Local Highway Authority Response to Planning Consultation

Planning Application:	98127/FUL/19	Pre-app?	No
Location:	Unit 1, Altrincham Retail Park, George Richards Way, Altrincham, WA14 5GR		
Description:	Extension, refurbishment, and subdivision of the existing Homebase store to provide a downsized unit for Homebase and a new Class A1 retail unit to be occupied by Lidl. The application also proposes the relocation of the Homebase garden centre, the reconfiguration of the existing car park and associated landscaping, and the creation of a new egress from the site.		
Planning Officer:	Bethany Brown	Date Received:	02/01/2020
Date of Response:	08/01/2020	Response No.:	04

LHA Response 04 only considers TTP Consulting supporting document 'Altrincham Retail Park Unit 1 - Response to Highway Comments in Relation to Planning Application 98127/FUL/19 - Dated 19 December 2019'.

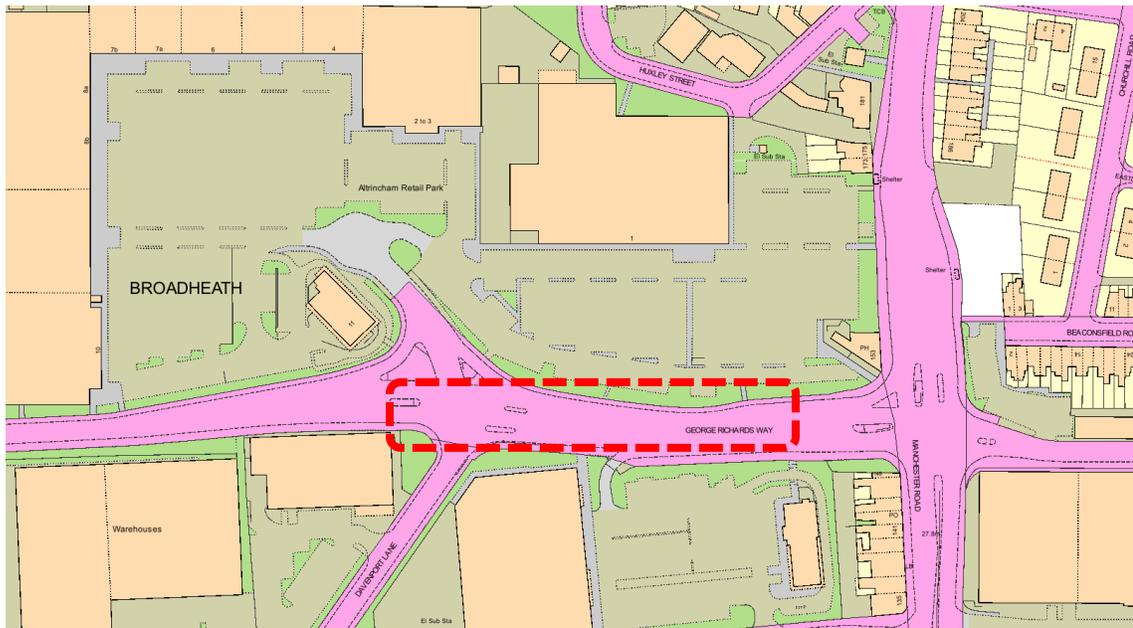
- I. Section 3 of the supporting document states it is proposed to install pedestrian guardrail along the full extent of the proposed traffic island which, has been extended in length to stop vehicles from turning right out of the proposed new access. It is also proposed to reduce the width of the island to 0.950m, with the exception of the ends which would be 1.2m wide (all works would be subject to a S278 Agreement).

- II. The nosing of the island would be 1.2m at each end which, would create a 'dog bone' shaped island. The LHA is concerned that the proposed alignment could potentially lead to a road safety issue as a result of the change in carriageway and kerbline alignment, and therefore requests that the design is amended accordingly. Refer to paragraphs 4.1.3 and 4.1.5 below.

- III. The proposed central island set-back is not clear from the plan provided. For information, for minor road junctions (and subject to the location of the island, including the position of the nosing), the minimum set-back should be 1m from the edge of the running carriageway.

- IV. Further to paragraph 4.1.2 above, physical traffic islands should be clearly visible to approaching drivers. It is accepted that illuminated bollards, and signs, and hazard road markings would be installed; however, drawing number 2019-3538.DWG-204 only shows a partial hatched road marking for the island which could result in vehicle kerb strikes.

- V. Assuming the road markings and other highway features shown on the drawing are representative of what is currently provided on site, it is indicated that the proposed island would impact the existing controlled crossing at the junction with Manchester Road. Therefore, the design team and developer, in consultation with TfGM, should amend the proposals to include the controlled junction, thus providing a single island.

- VI. It is proposed to install pedestrian guard rail along the full length of the island to prevent the central island from being used as a crossing facility. In addition to future maintenance requirements, guard railing can be unsightly, resulting in a cluttered and 'closed' environment. In some instances, cyclists can be pushed across the traffic lane and into the railings. (as noted in research undertaken by Southampton University). Further evidence also suggests people will still walk alongside the railings if they perceive they can shorten their journey by doing so (regardless of the possibility that they may also be putting themselves at greater risk of being struck by a passing vehicle).

- VII. With no physical barrier currently in place vehicles are currently afforded the opportunity to enter the centre hatched area in the event of an incident e.g. to avoid a potential sideswipe collision with another vehicle. Should a traffic incident occur at this location following construction of the island, the proposed guard railing would be another object in the carriageway that could be hit, particularly given the proposed length of railing to be installed. Guard railing should only be introduced where there is a clear, identified need for it.

- VIII. The design team should investigate alternative low maintenance options to encourage pedestrians not to utilise the island as a crossing, that would not denigrate the existing streetscape.

- 3.2.1 The LHA would request that the proposed left turn only egress and the associated central traffic island are removed from the development proposals. However, to address comments made in the supporting document '*Altrincham Retail Park Unit 1 - Response to Highway Comments in Relation to Planning Application 98127/FUL/19 - Dated 19 December 2019*', the LHA would state the following:
